NOTICE OF ADOPTION

BY THE ARCHITECTURAL REVIEW BOARD

**STAFF REPORT
RECOMMENDATION TO THE ARCHITECTURAL REVIEW BOARD**

Case #:	AR17-0006
Project:	IPT Tualatin
Location:	12155 SW Tualatin-Sherwood Rd
Tax Map/Lots:	2S1 27BC 00200
Applicant/Owner:	VLMK Engineering + Design / IPT Tualatin DC LLC
Applicant/Rep.:	Jennifer Kimura, VMLK Engineering + Design, Portland, OR jenniferk@vmlk.com

South Elevation of the proposed building, facing SW Tualatin-Sherwood Road

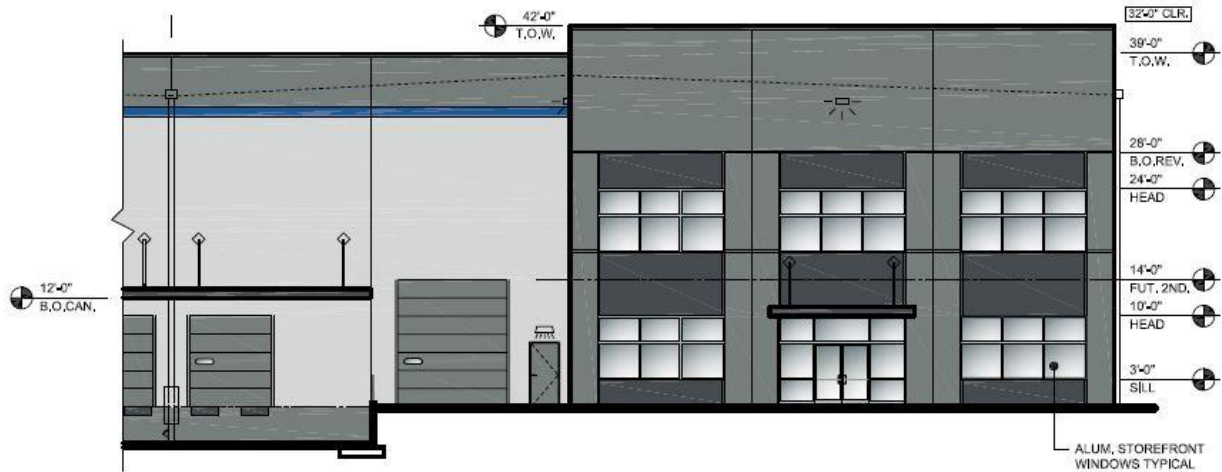
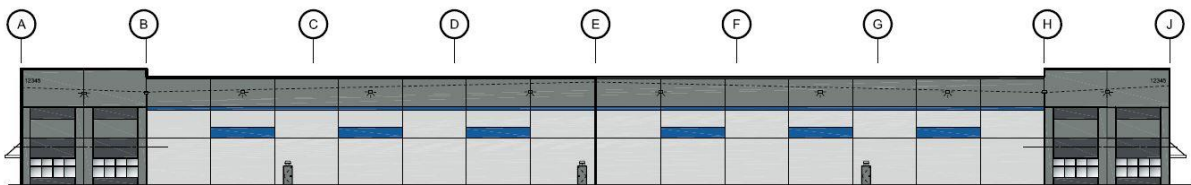
Staff finds that the proposed development would be consistent with existing and similarly developed industrial uses in the immediate vicinity, most notably the Intel Corporate Center at 12310-12370 SW Cimino Street immediately adjacent to the west. While the remaining properties in the immediate vicinity include a mix of undeveloped parcels, farmland, and a smattering of single-family homes, the wider area is mapped with General Manufacturing (MG) and Manufacturing Business Park (MBP) planning districts with the expectation that these areas would eventually redevelop into manufacturing uses similar to those proposed on the subject site. These standards are met.

The proposed building is composed of tilt-up concrete panels and anchored with corner elements, industrial-style canopies, and clear aluminum storefront windows. The proposed building shares a number of design elements with the Intel Corporate Center to the west, including: a second set of windows near the building corners—giving the appearance of a second interior floor; loading docks oriented away from public right-of-ways; and the use of color and accents to minimize building massing.
